Resolution of the Direct Containment Heating Issue for All Westinghouse Plants With Large Dry Containments or Subatmospheric Containments

Resolution of the Direct Containment Heating Issue for All Westinghouse Plants With Large Dry Containments or Subatmospheric Containments

Appendix A	Peer Review of NUREG/CR-6338.....	A-1
Appendix B	Melt Mass/Composition Distributions.....	B-1
Appendix C	Plant Geometry.....	C-1
Appendix D	Catalog of IPE Containment Fragility Curves for Operating Pressurized Water Reactors (PWRs).....	D-1

Figure D.6 Comparison of reinforced concrete containment fragility curves (medium pressure).

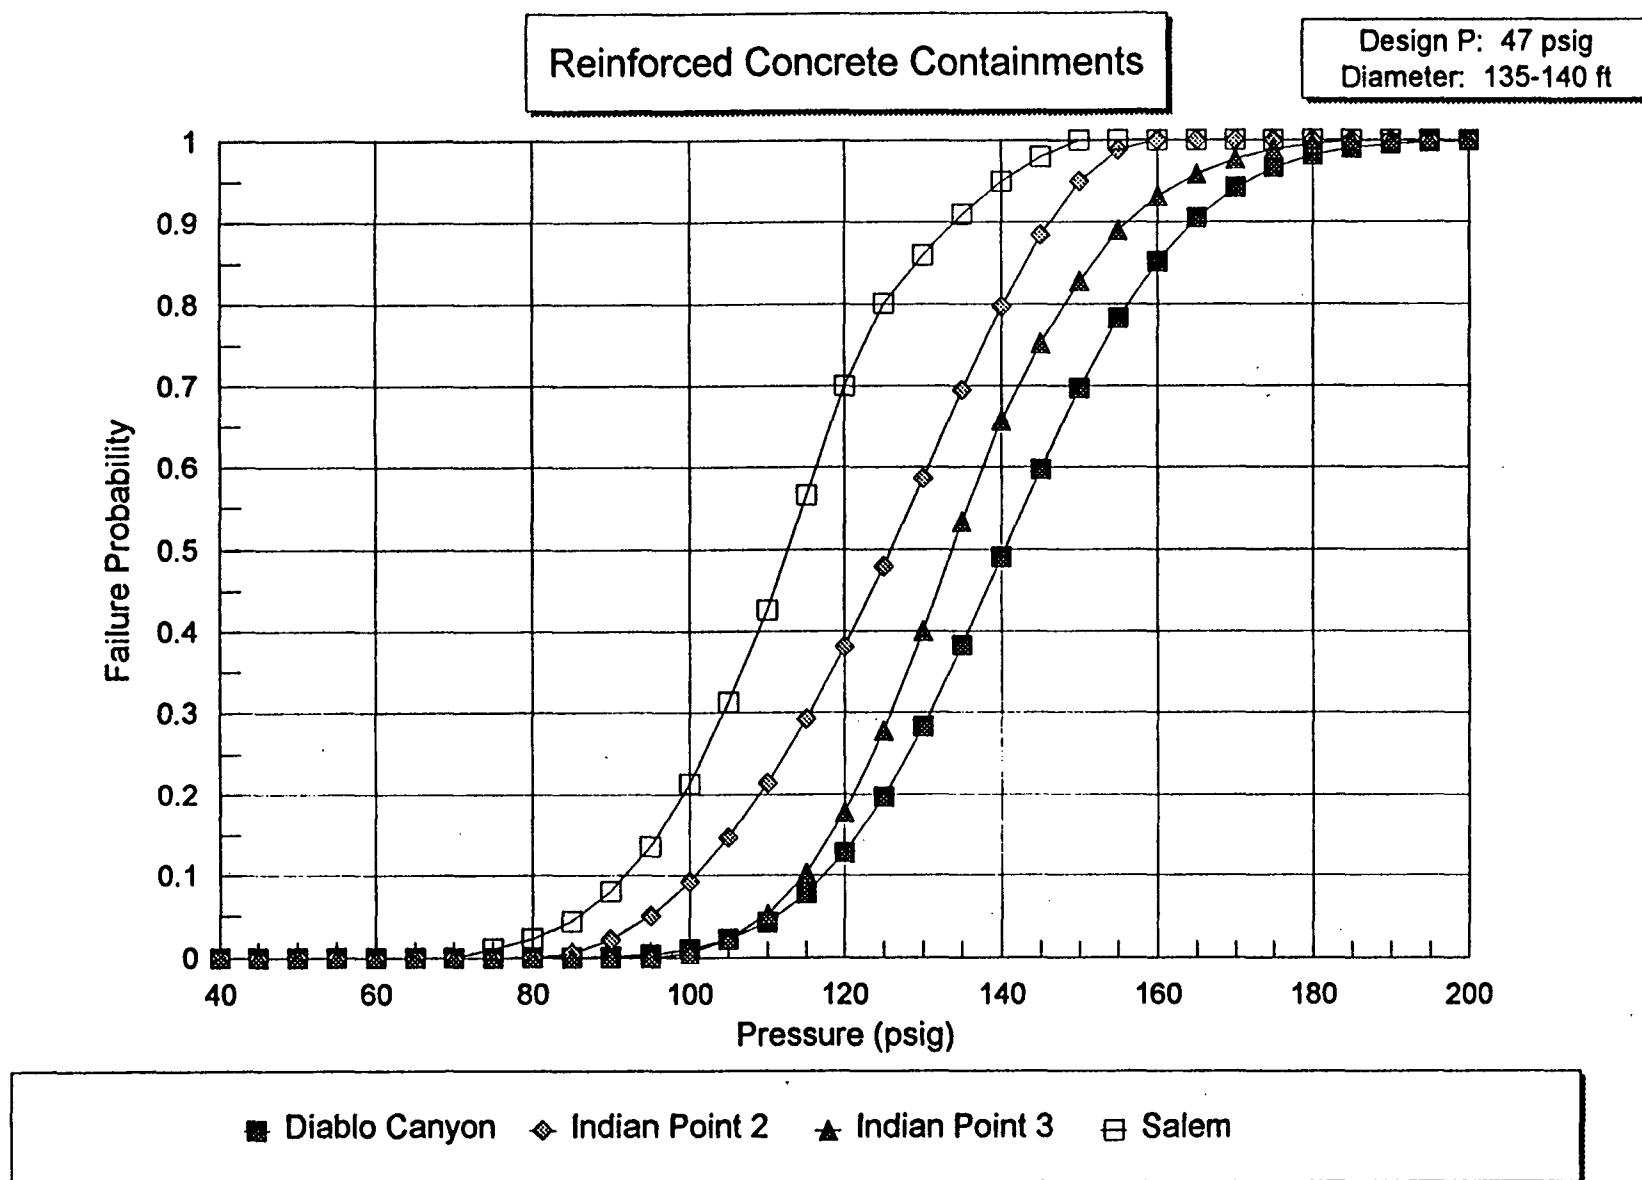
Page D-15; Section D.4.2: Some fragility curves reported and compared in this section are not about the plants within the scope of this study. For example, fragility curves of some ice condenser, CE and B&W plants are presented. Also, I fail to see the main purpose and significance of this comparison effort in the CCFP calculations. For example, Figures D.1 through D.17 seem to have no or small relevance to this analysis.
